Highgate Conservation Area Advisory Committee objection to [HGY/2023/2976](#) for 36 Cholmeley Park, London N6 5ER

Photo taken from Google Streetview

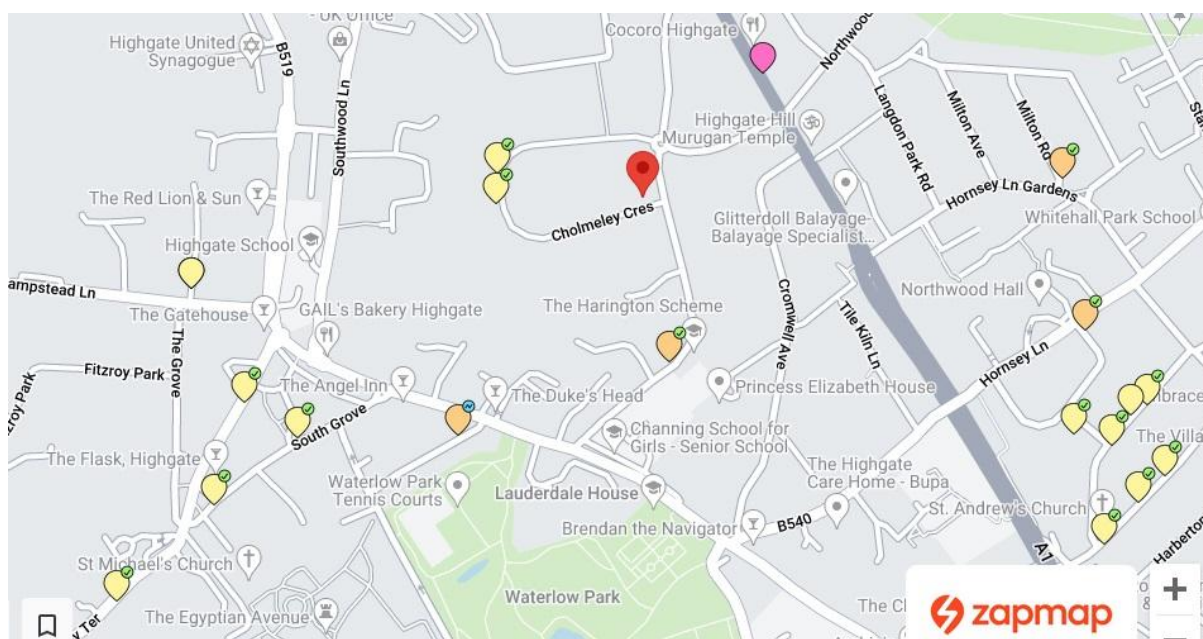
This front garden forms part of a significant run of greenery along this side of Cholmeley Park, which contributes significantly to the typically leafy “open, semi-rural or village character” of Highgate Conservation Area. Replacing this front garden with a parking area would damage the Highgate Conservation Area. There would also be a loss of on street parking.
